Technical Bulletin

BULLETIN NO. 091119

PRODUCT: Olsen and Airco Oil Furnaces equipped with Beckett AF Burners & Fan/Timer Boards

TITLE: Possible Wiring Error in Burner / Fan/Timer Board Wiring

Photo 1

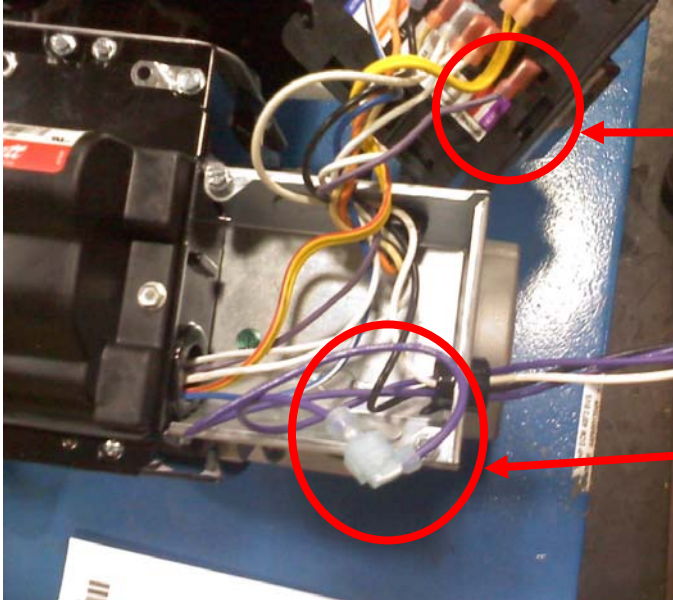
The before mentioned situation will occur if the two violet wires from the 4-pin Molex connector under the burner primary control are connected together, and the gray wire from the CleanCut solenoid coil is on the "VALVE" terminal of the primary control. See photo 1.

Gray wire from solenoid coil connected to VALVE.

2 violet wires from 4-pin Molex connector are incorrectly connected together.

Photo 2

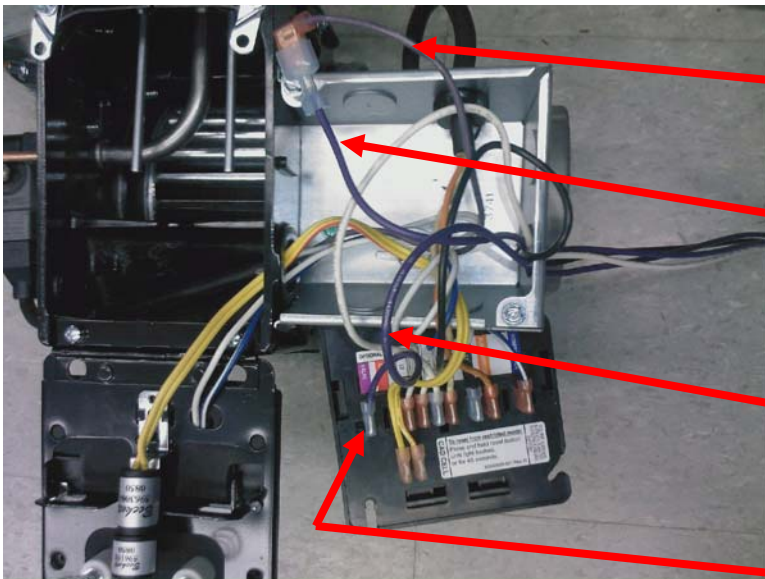
Gray wire from solenoid coil

Violet wire with 1/4" Quick-Connect male terminal

Violet wire with 1/4" Quick-Connect female terminal

VALVE terminal on R7184B oil primary control

1. Separate the two violet wires under the primary control from each other.
2. Remove gray wire from solenoid from the VALVE terminal and attach to one of the violet wires.
3. Put the remaining violet wire on the VALVE terminal.
